SERVICE BULLETIN

BULLETIN NO: 21-001

TITLE: Transmission Support Strap Conversion Kit

PRODUCT SERIES / MODEL: MARK IV Production / Switch Tampers with Durst or Cushman Drive Transmissions

SECTION G-G

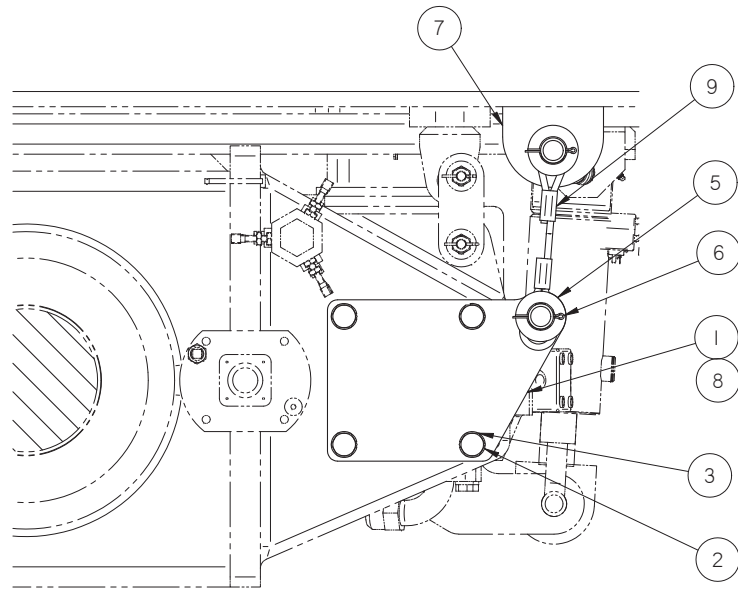
1. Prior to removing components, place a leak-proof container beneath the gearbox to catch any lubricant that may run out.
2. Remove existing cover plate (see Section G-G in the attached drawing in this Service Bulletin) located on the opposite side of the transmission from the hydraulic drive motor.

3. Install Transmission Hanger Weldment plate (1) and new O-Ring (8) being careful not to damage the O-Ring. Secure with four new fasteners (2) and (3).

REMOVE EXISTING COVER (THIS END ONLY), AND USE ITEM 1 AS A REPLACEMENT.

CAREFULLY HANDLE TO AVOID DAMAGING NEW O'RING SEAL.

FOR SERVICE USE #172582-1 O'RING.

SECTION D-D

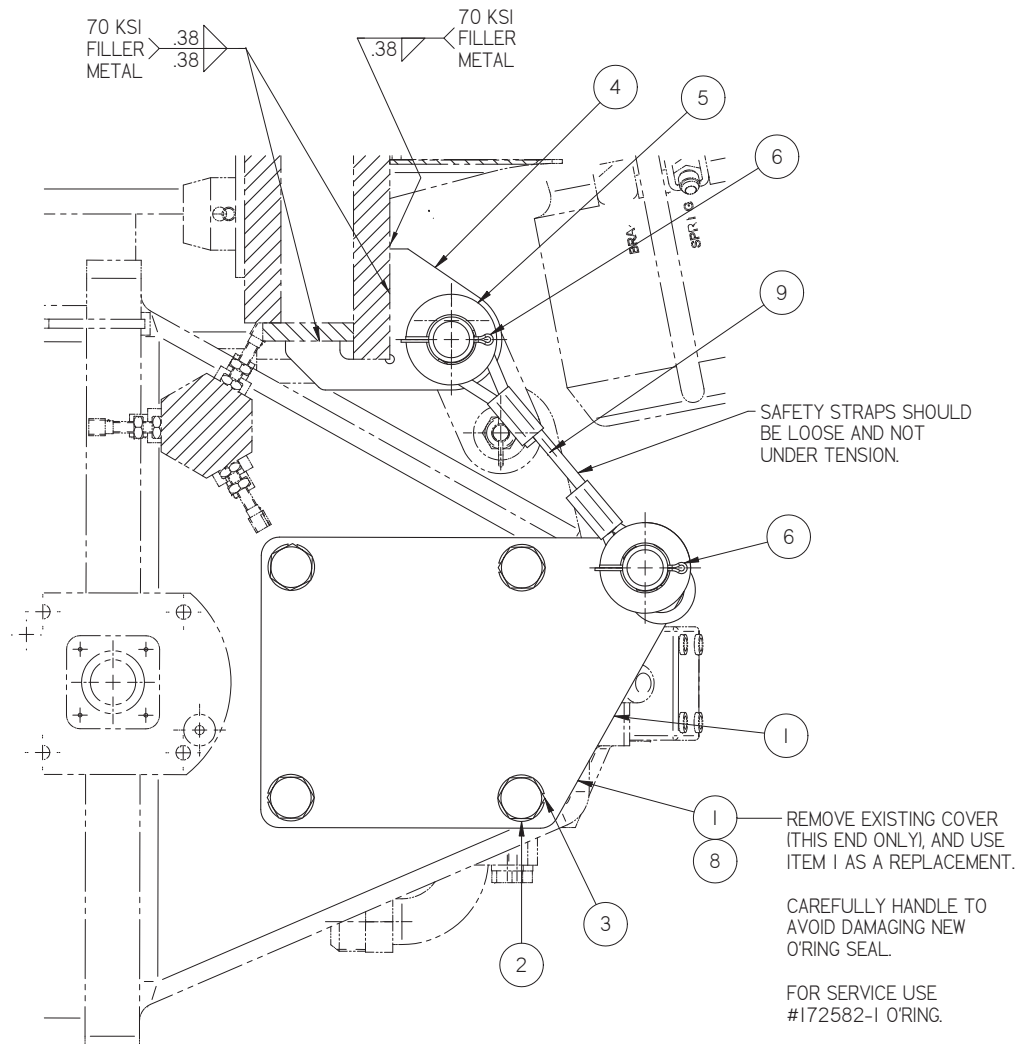
1. Prior to removing components, place a leak-proof container beneath the gearbox to catch any lubricant that may run out.
2. Remove existing cover plate (see Section D-D in the attached drawing in this Service Bulletin) located on the opposite side of the transmission from the hydraulic drive motor.

3. Install Transmission Hanger Weldment plate (1) and new O-Ring (8) being careful not to damage the O-Ring. Secure with four new fasteners (2) and (3).
